**STATE OF DELAWARE
EXECUTIVE DEPARTMENT
OFFICE OF STATE PLANNING COORDINATION**

RE: PLUS review 2016-03-02; Colony at Summit Bridge East

Thank you for meeting with State agency planners on March 23, 2016 to discuss the proposed plans for the Colony at Summit Bridge East development. According to the information received, you are seeking review of a 74 unit subdivision on 60.3 acres in New Castle County.

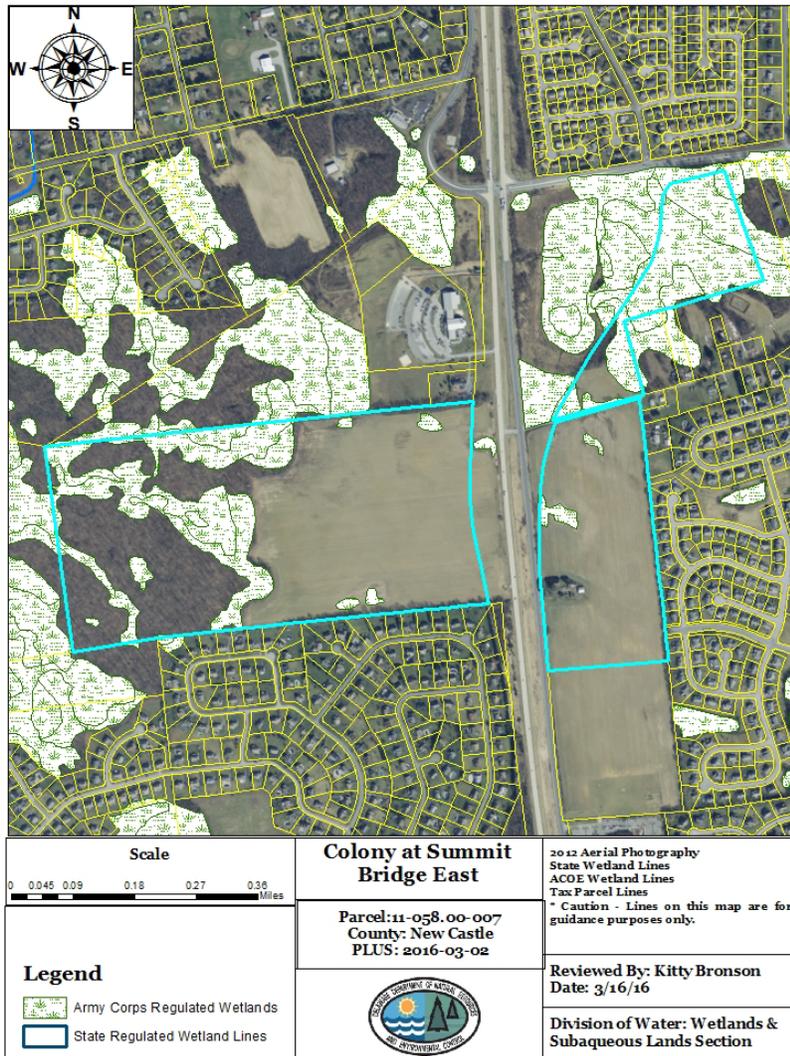
- Based on soils survey mapping update, the soil mapping unit with the most limitations for development on this parcel is Fallsington (FgA; Figure 1). Fallsington is a poorly-drained wetland associated (hydic) soil mapping unit that has severe limitations for development (considered unsuitable). We strongly discourage building on hydic soils because they are functionally important source of water storage (functions as a “natural sponge”); the loss of water storage through excavation, filling, or grading of intact native hydic soils increases the probability for more frequent and destructive future flooding events. The probability for flooding is compounded by increases in surface imperviousness as building density in the area increases over time. Moreover, destruction of hydic soils increases the amount pollutant runoff (i.e., hydic soils sequester and detoxify pollutants) which contributes to lower water quality in regional waterbodies and wetlands.

We strongly recommend the applicant contact a licensed (Delaware Class D) soil scientist to make a site specific assessment (i.e., soil survey mapping) of the soils on this site. A list of licensed soil scientists can be obtained from the Ground Water Discharges Branch; the Branch can be reached by phone at 739-9947.
